Planning Applications Committee

Title	PLANNING APPLICATION REPORT
Ward	Thames Ward
Planning Application Reference:	PL/25/0697 Removal/variation of conditions
Site Address:	Former Gas Holder site, Alexander Turner Close, Reading, RG1 3EA
Proposed Development	Demolition of existing buildings and Gas Holder and the erection of new buildings ranging between 2 and 9 storeys in height, providing 130 residential units (Class C3) with associated access, car parking, landscaping and open space without complying with conditions 2 (approved plans), 11 (noise mitigation), 12 (ventilation strategy), 26 (SuDS) and 35 (vehicle parking) of planning permission ref. PL/19/0627 for changes to design, layout, unit mix, vehicle parking, refuse storage, landscaping, noise mitigation, ventilation strategy and energy strategy
Applicant	Mr Joshua Austin
Report author	Matthew Burns
Deadline:	13 week decision date: 22/08/2025 Extension of time date: 31/07/2026

Recommendations	GRANT Variation of conditions of planning permission PL/19/0627 as specified below
Conditions	<i>All condition number references as per original planning permission decision notice attached as appendix 3 to this report</i> <u>Varied C

Figure 11 – Proposed Building B South Elevation (proposed changes shown circled)

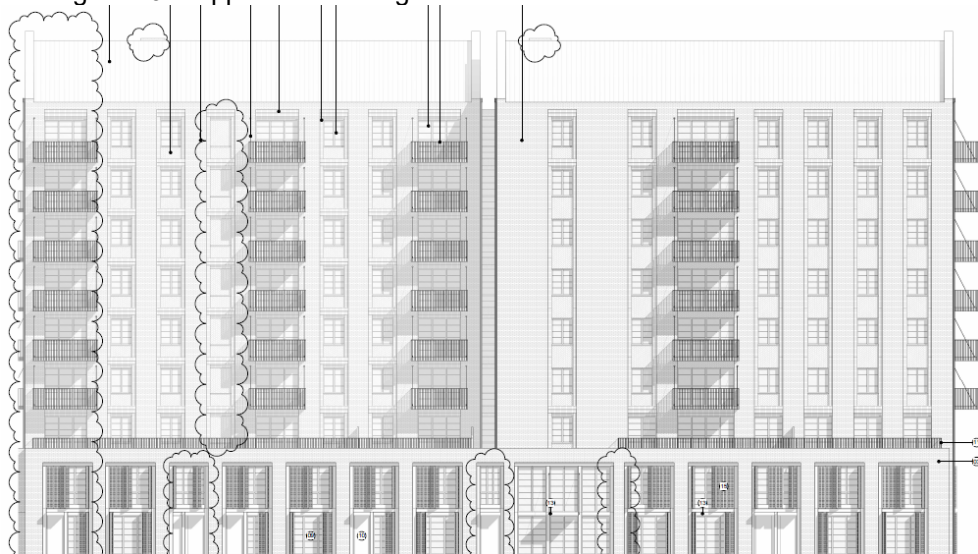
- 7.7 The most notable proposed change relates to Building B, the tallest building within the development at 9 storeys, which is proposed to be increased in width between the 1st and 8th floors by 3.5m to accommodate the additional stair and lift core in order to comply with latest Building Regulations and Fire Safety legislation. The increase in width would extend the upper floors of the building further west above the approved single storey part of the covered car park area meaning the overall footprint of Building B would not increase just the width of the upper floors. The appearance of the external elevations of the building would remain as approved, just wider with an additional column of windows to serve the new stair core which would reflect the appearance and proportions of the approved windows to Building B. Approved and proposed south elevation of Building B is shown in figures 10 and 11 below which shows these changes.

- 7.7 As the largest building within the development the increase in width of the building would have a visual impact notably when viewed from the River Kennet, albeit it is considered that this impact would not be a significant one when viewed in the context of the approved development as a whole nor one which would be detrimental to the appearance of the development as a whole when viewed from the surrounding area.

Figure 15 – Proposed Building B North Elevation (proposed changes shown circled)

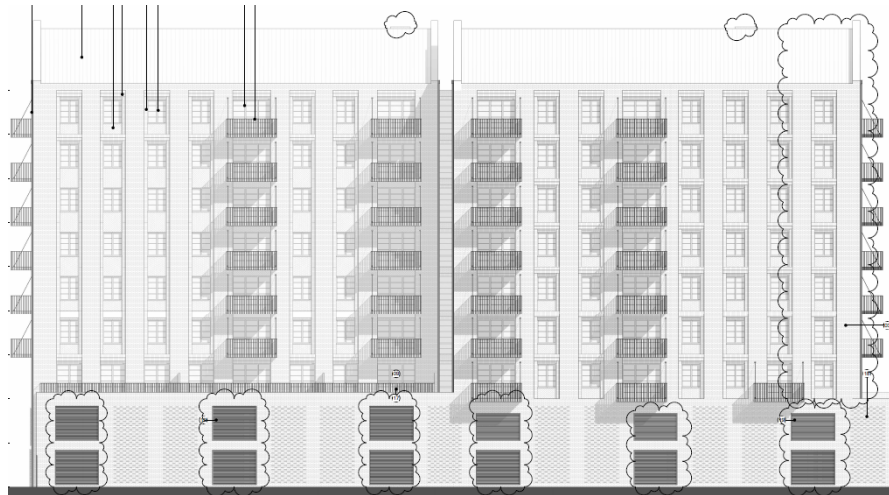
- 7.9 Further changes are proposed to the ground floor elevations of Building B with the addition of ventilation louvres to the ground floor car park level of Building B to the north elevation facing the railway and additional windows to the south elevation serving the new stair core. No concerns are raised in respect of these changes from a visual perspective; the louvres would introduce some limited visual interest in what under the approved scheme is a plain brick wall (see figures 14 and 15 below).

Figure 18 – Refuse Collection Points (Highlighted Green)

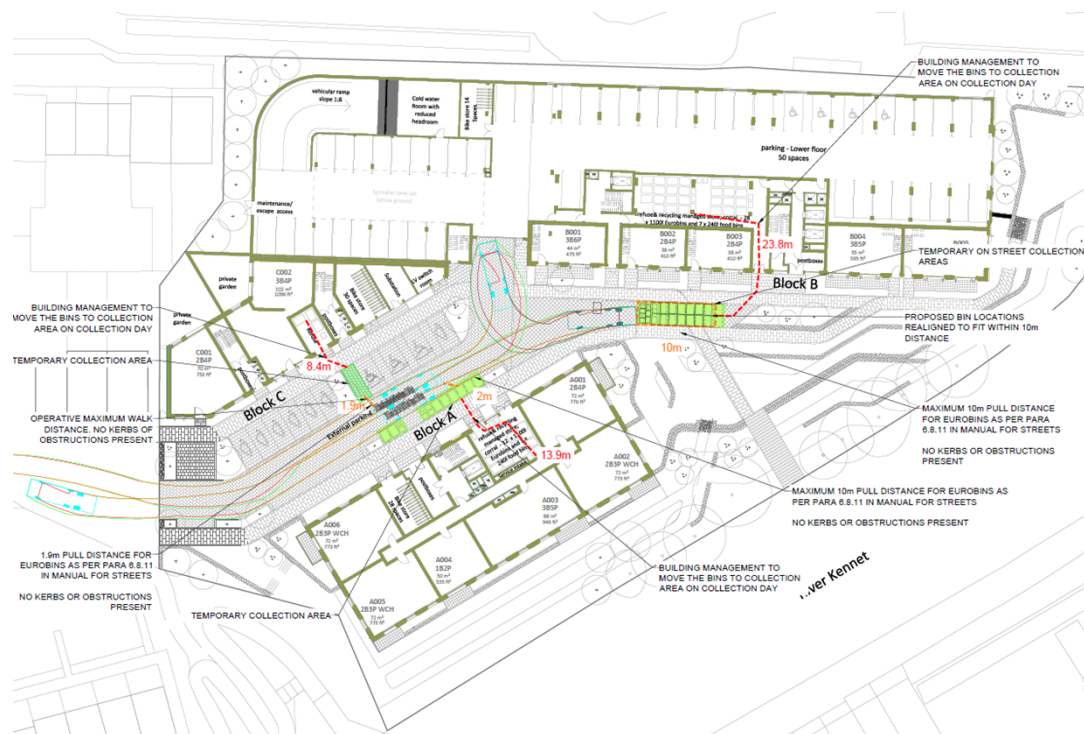
7.28 The approved bin stores within each building have been enlarged to accommodate food waste bins. This is because food waste collection service was not offered by RBC when planning permission for the approved development was granted. RBC Waste Officers have reviewed the stores and are satisfied that these are of adequate size for the requisite number of bins required for each building. Revised refuse collection points within the site have also been proposed and are considered to be acceptable by RBC Waste Officers with these all being located within 10m of the access road and therefore appropriate for the RBC Waste Collection Operatives to empty to bins into the refuse collection lorries. Figure 18 below shows the refuse collection points highlight in green and the routes from the stores to the collection points shown with a red dotted line. The submitted Waste Strategy plan confirm that building management staff would be responsible for moving the bins from the stores to the collection points and back on collection days. Condition 5 of the extant permission would be updated to secure that the development is carried out and operated in accordance with the updated waste storage and collection arrangements and condition 40 from the extant permission would be re-applied to secure details of measures to prevent pests and vermin accessing the bin stores are submitted and agreed with the LPA prior to occupation of the development. The revised waste storage and collection proposals for the site are acceptable and would comply with Policy CC5 (Waste Minimisation and Storage).

- 7.29 Swept path drawings have been submitted to demonstrate how waste collection vehicles would access the waste collection points and turn within the site in order to enter and leave in forward gear. RBC Transport Officers have reviewed the swept path plans and are satisfied that safe access to the waste collection points and within the site generally would be achieved. Suitable access to the waste collection point for Building B would be provided as a result of the 10m extension of the access road in front of this building.

Figure 19 – Proposed trees to be relocated shown in brown and proposed new trees shown in green

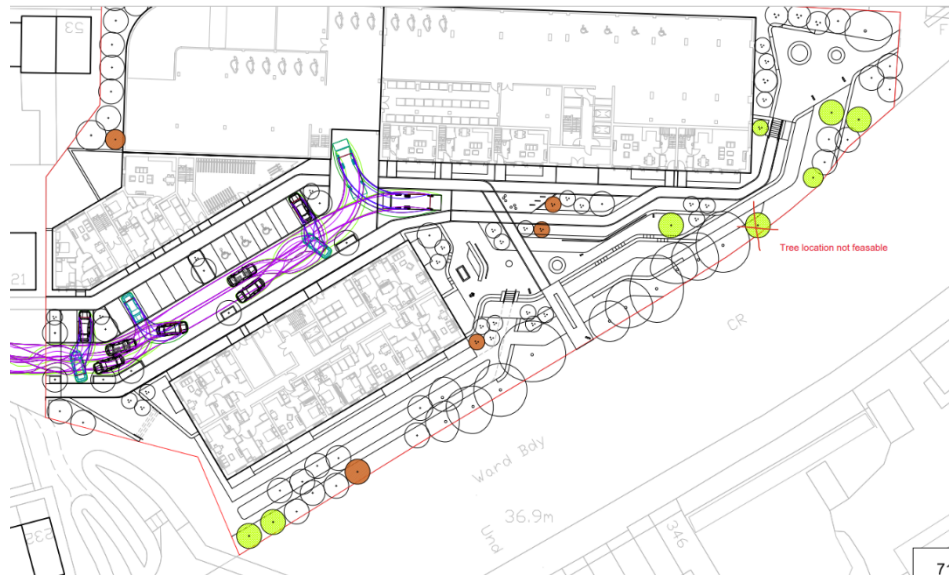
- 7.32 The RBC Natural Environment Officer is satisfied with the proposed siting of the 5 trees to be relocated within the development as well as the siting of the 8 new trees to be planted to provide mitigation for partial loss of the green roof to the car park. Figure 19 below shows the proposed locations for the trees to be re-located and for the additional new trees. The amended development is considered to ensure that there would be no additional harm to retained trees and would, as per the approved scheme, continue to provide an acceptable landscaped setting for the development next to the river in accordance with Policies EN14 (Trees, Hedges and Woodland), CC7 (Design and The Public Realm), CR2 (Design in Central Reading), CR3 (Public Realm in Central Reading) and EN11 (Waterspaces). Conditions 33 and 38 of the extant planning permission require full details of the hard and soft landscaping and boundary treatment details for the development to be submitted and approved by the LPA prior to commencement of development beyond foundation level and this condition would be carried across and re-applied to a s73 variation of condition planning permission.
